In Reply Refer To:
HSST-1/B-69E

- Concrete Reactive Tension System (CRTS) and Steel Reactive Tension System (SRTS) modifications

Name of system:	Concrete Reactive Tension System (CRTS) and Steel Reactive Tension System (SRTS) modifications
Type of system:	Longitudinal Barrier
Date of original request:	December 23, 2015
Original FHWA letter:	B-69 dated June 27, 2000
FHWA Control number:	B-69E

Oversized hole

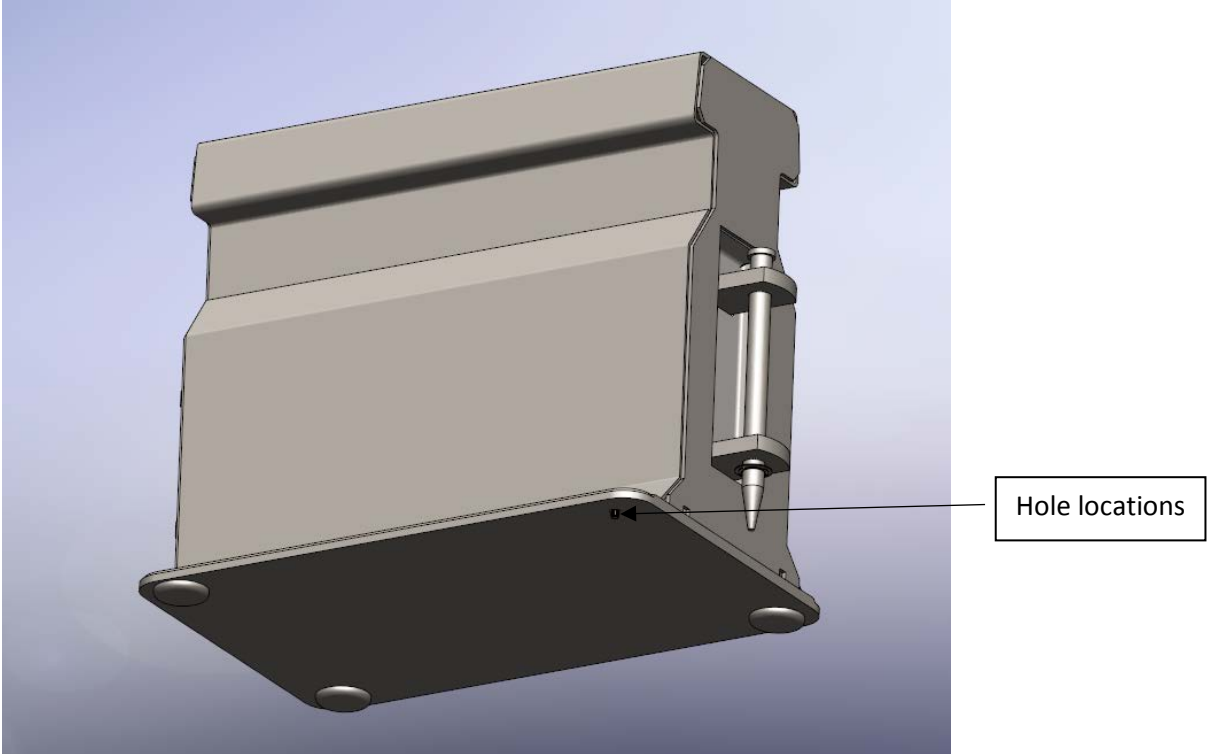
1) Each SRTS barrier element is equipped with 4 rubber feet that are attached to the barrier through clearance holes at the four corners of the base-plates. The holes are slightly larger than what is required for the 1/2" bolts connecting the feet. As a result, there is the potential for the bolts to work themselves loose over time due to excess wiggle room. This request is for the acceptance of a slight reduction to the diameter of the clearance holes in the base-plates. This modification represents no change to the function, capacity or performance of the barrier element or the longitudinal barrier system as a whole.

New clip is shown on the left and the old clip on the right.

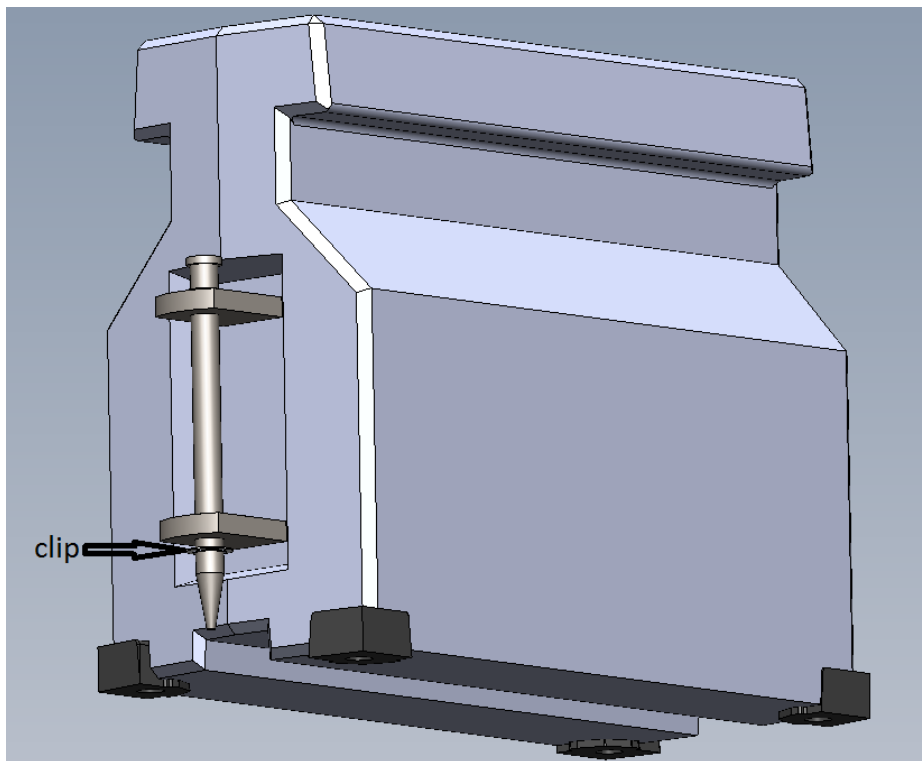
2) All RTS barrier elements are pinned together using a large 1-3/8" diameter pin. The pins have a small groove receiving a retaining clip that prevent the pins from working themselves out during the barrier transfer. Over the years a number of clips have fallen off. The failures are believed to be caused by fatigue. A stronger clip/washer configuration has been identified and proven to be up to 10 times more durable in bench testing. This request is for the acceptance of an alternative retaining clip. The clip does not come into play during crash testing, therefore this modification represents no change to the function, capacity or performance of the barrier element or the longitudinal barrier system as a whole.

New Pusher Plate on the left

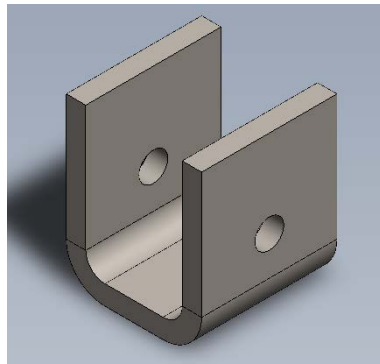
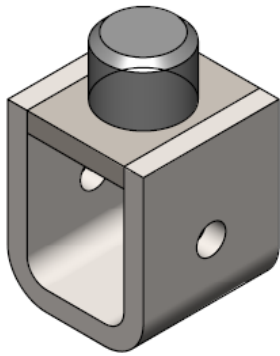
3) There are two springs at each joint where the pins connect the RTS barrier elements. These springs apply pressure on the pins connecting the RTS barriers such that any slop in the hinges is removed and the barriers are always in tension (this is how the barrier gets its Reactive Tension name). Having the barriers in tension helps reduce the deflection of the barrier wall during a crash. The springs sit in a mild steel housing and push against a "U" shaped plate that pushes against the pin. Over the years it was noticed that some springs have the potential of wearing a groove in the spring housing and occasionally get snagged in this groove such that they no longer apply pressure on the pin. A new "U" shaped plate was developed that has a small cylindrical rod welded to its ends. This rod keeps the spring centered in the spring housing preventing it from wearing out the spring. This new "pusher plate" can be used on new barriers going forward as well as to retrofit old barriers that were damaged by a wandering spring. The pusher plate is centrally located between the barriers and does not come into play during crash testing, therefore this modification represents no change to the function, capacity or performance of the barrier element or the longitudinal barrier system as a whole.

Old cap on the left.

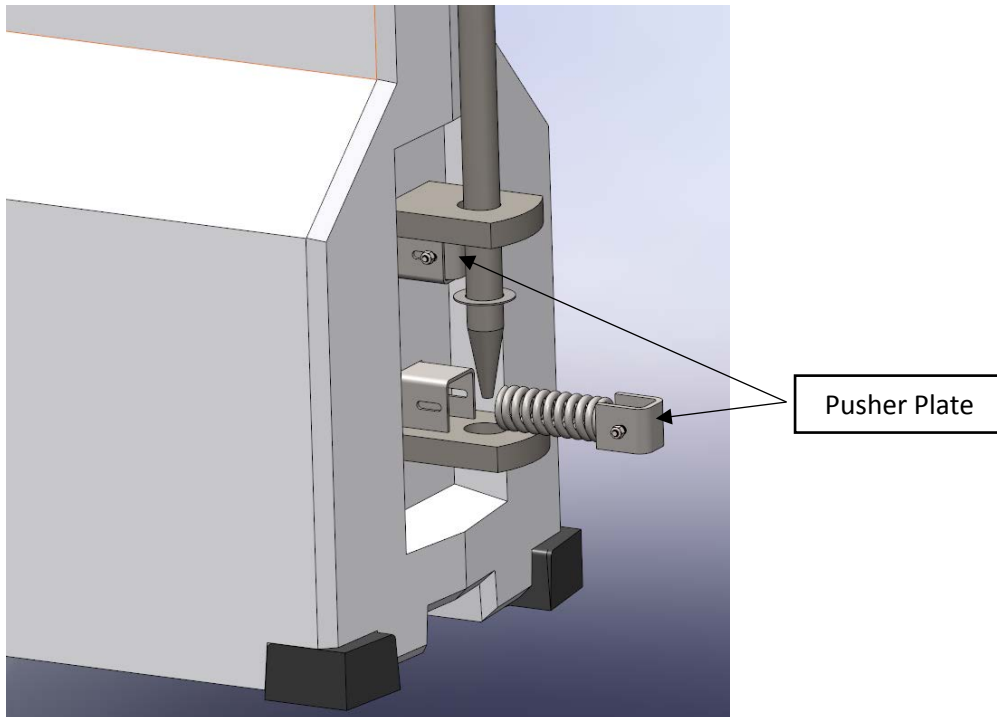
4) A key components of these longitudinal barriers is the Variable Length Barrier (VLB). The proposed modification involves the replacement of a cap internal to the VLB. The VLB has a hydraulic cylinder that is connected to a hydraulic reservoir. This reservoir has a small breather cap. The original caps were made of black plastic (ABS) and weigh approximately 1.1 ounces. Occasionally these caps got damaged and sometimes went missing. The new cap is a more durable steel cap that weighs roughly 1.3 ounces. The weight difference is negligible considering the overall weigh of a VLB is 800lbs. Therefore, this modification represents no change to the function, capacity or performance of the barrier element or the longitudinal barrier system as a whole.
